SUBJECT: TURKEY POINT NUCLEAR GENERATING, UNIT NOS. 3 AND 4 - STAFF
ASSESSMENT OF RESPONSE TO 10 CFR 50.54(f) INFORMATION
REQUEST - FLOOD-CAUSING MECHANISM REEVALUATION (TAC NOS.
MF1114 AND MF1115)

STAFF ASSESSMENT BY THE OFFICE OF NUCLEAR REACTOR REGULATION
RELATED TO FLOODING HAZARD REEVALUATION REPORT
NEAR-TERM TASK FORCE RECOMMENDATION 2.1
RELATED TO THE FUKUSHIMA DAI-ICHI NUCLEAR POWER PLANT ACCIDENT
TURKEY POINT NUCLEAR GENERATING, UNIT NOS. 3 AND 4
DOCKET NOS. 50-250 AND 50-251

Figure 3.2-1 Example of FLO-2D results, showing maximum water depths predicted in modeling of LIP Scenario A over the entire model domain. (Source: FHRR Figure 4-6)

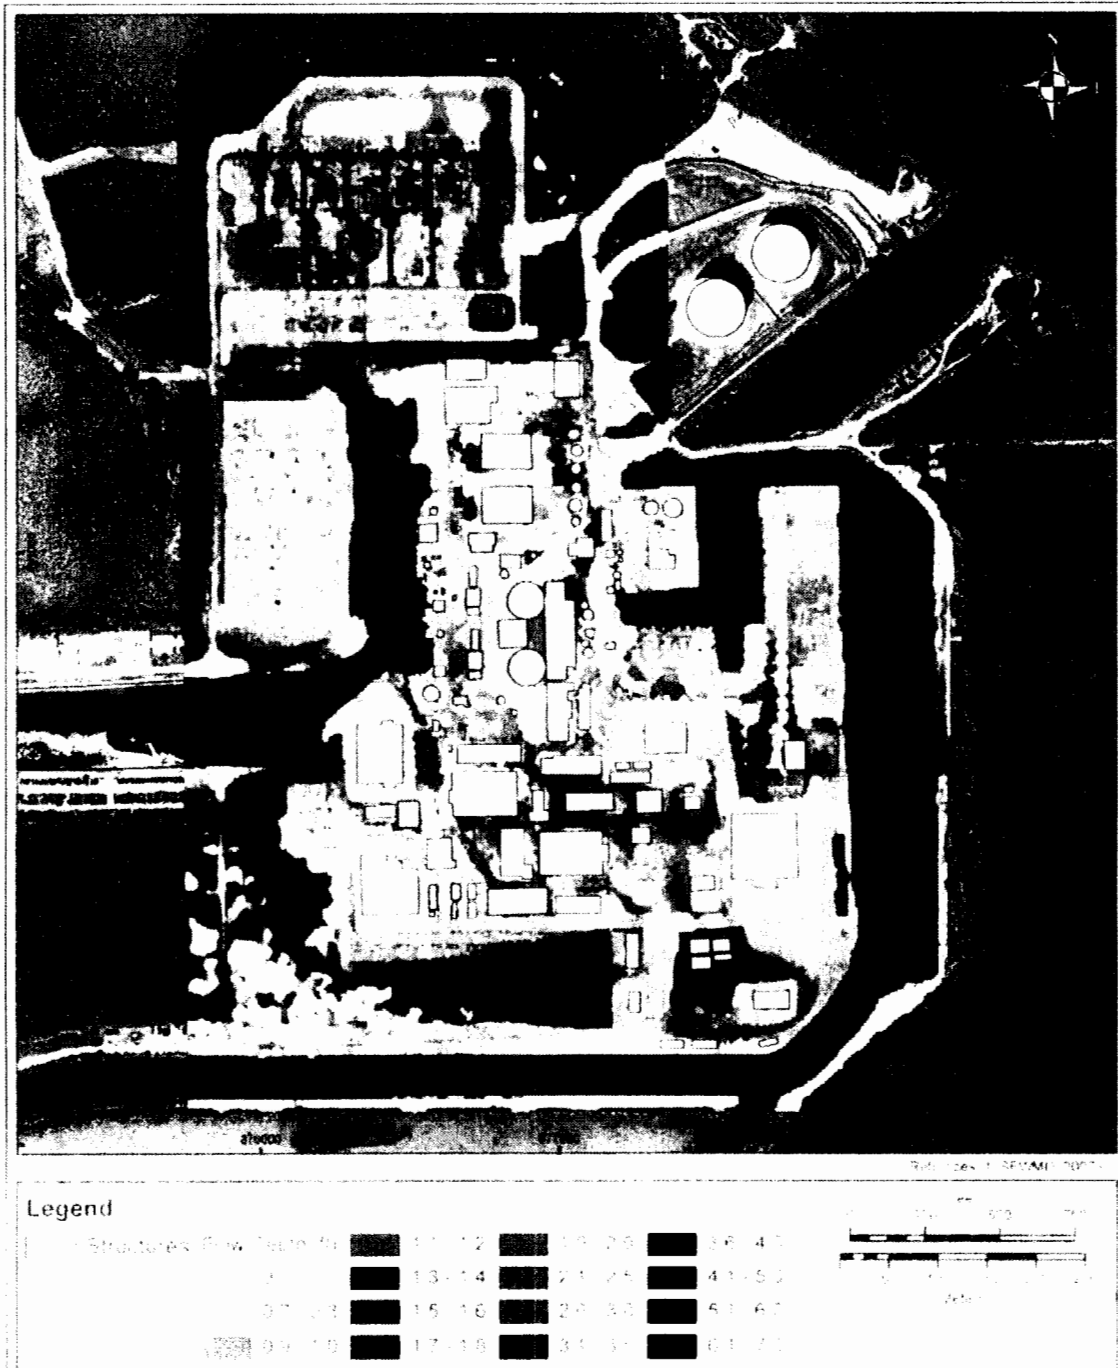
The licensee used FLO-2D to simulate the generation and flow of runoff from the one-hour PMP event, represented by applying the rainfall over the model grid at one-minute increments, as indicated in Table 3.2-2. Figures 3.2-1 and 3.2-2 illustrate the results of one model run for Scenario A. Figure 3.2-2 shows the locations of POIs. The licensee did not provide similar figures for Scenario B in its FHRR.

The staff reviewed details of the licensee's FLO-2D model implementation and determined that the approaches and assumptions were conservative. The model output files reviewed by NRC staff did not report any errors related to model stability or mass balance. Additionally, staff performed confirmatory analysis using FLO-2D with one of the licensee's input data sets and confirmed the licensee's results.

The staff identifies the peak water surface elevation of 20.8 ft (6.3 m) determined for CCW3 Area for LIP Scenario B as the reevaluated flood hazard elevation for LIP during periods when hurricane preparedness measures are in place. For other time periods (LIP Scenario A), the staff identifies the peak water surface elevation of 17.2 ft (5.2 m) as the reevaluated flood hazard elevation.

Figure 3.2-2 Locations of numbered points of interest⁽¹⁾, with maximum water depths predicted in one FLO-2D model run for LIP Scenario A. (Source: Modified from FHRR Figure 4-7)

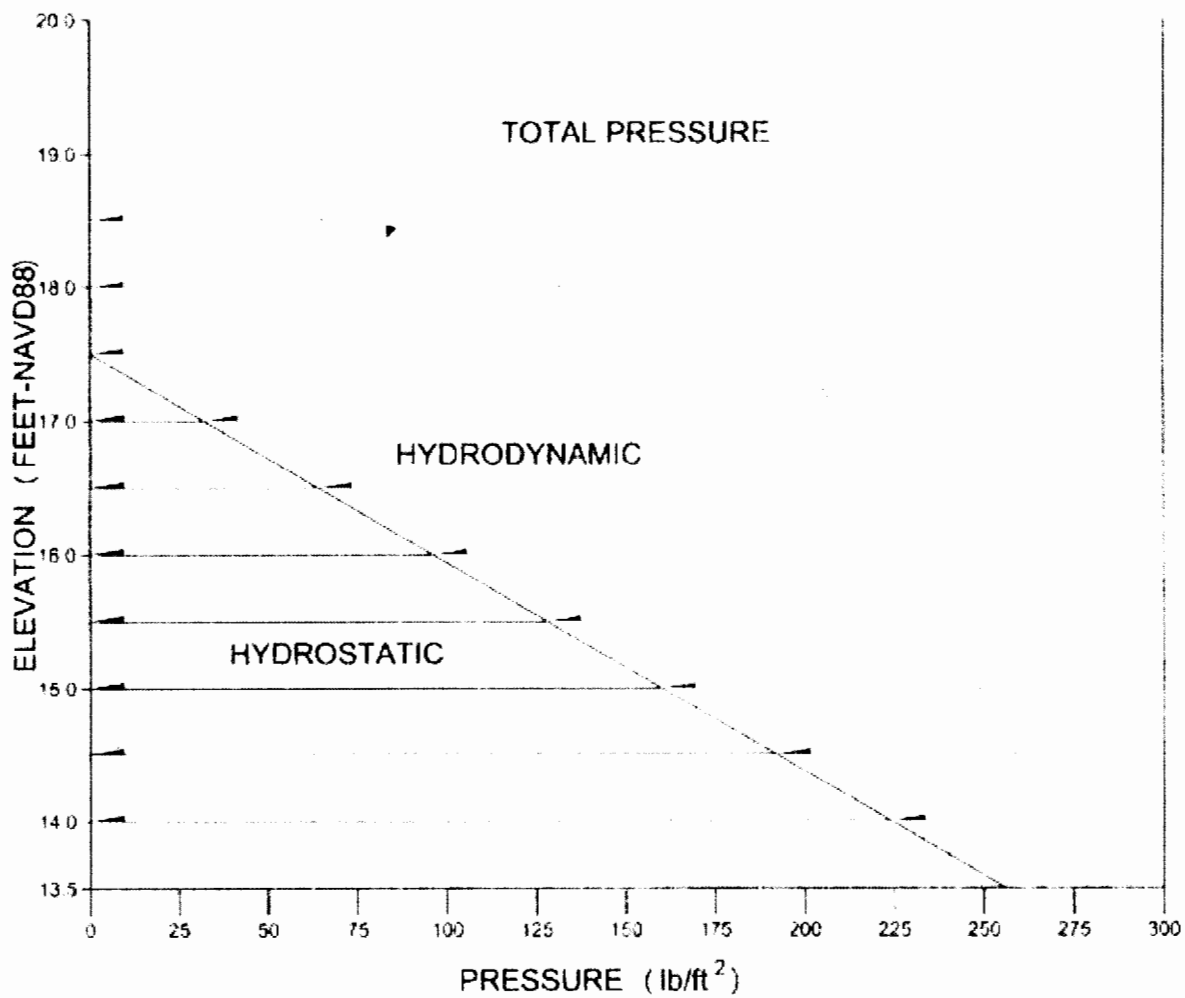
For LIP Scenario A, the licensee reported maximum flood water depths and elevations at 33 POIs; the greatest depth of water (above ground surface) at a POI location is reported as 1.7 ft

(0.5 m), corresponding to elevation 17.2 ft (5.2 m), for a POI in the CCW3 Area. For LIP Scenario B in CCW3, the licensee's letter indicates a peak water depth of 5.0 ft (1.5 m); for CCW4 the peak water depth was 1.3 ft (0.4 m). The corresponding water surface elevation for CCW3 was reported as 20.8 ft (6.3 m). The licensee stated that the revised peak water level in CCW3 exceeded the peak levels previously reported for LIP Scenario B and "was found to challenge SSCs" in that area. The licensee stated that it would implement interim actions to block runoff into the CCW areas before the hurricane season and that it had entered the revised flooding results for the CCW area and the need for interim actions into its corrective action program.
